PRODUCT / PROCESS CHANGE NOTIFICATION

PCN-000809

Date: MAY-04-2022

Semtech Corporation, 200 Flynn Road, Camarillo CA 93012

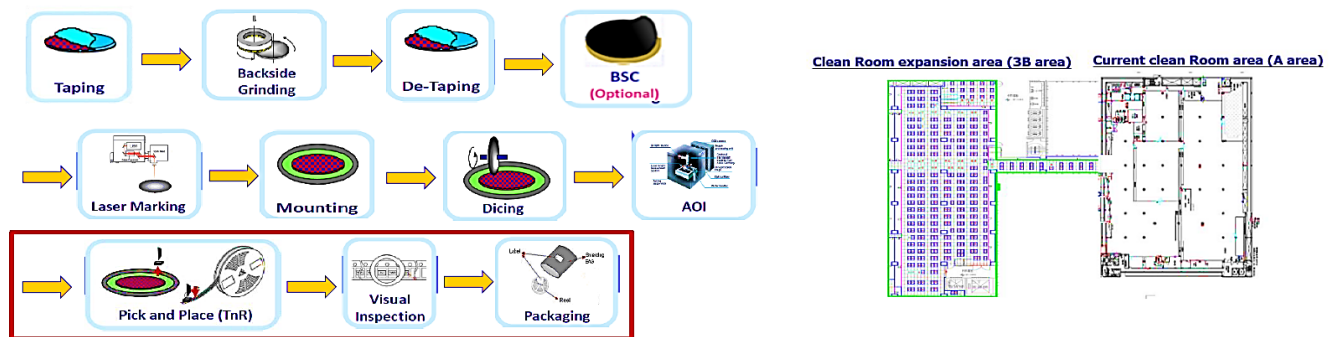
Chipbond, Semtech's supplier, is moving its current machines to a clean room expansion area adjacent to the current clean room area via a connector bridge. The clean room areas have their own central air conditioning, electricity, vacuum pump, and ESD ground, but the control specifications are the same and third-party certified.

As shown in the figure below, the impacted processes have been highlighted with a red box.
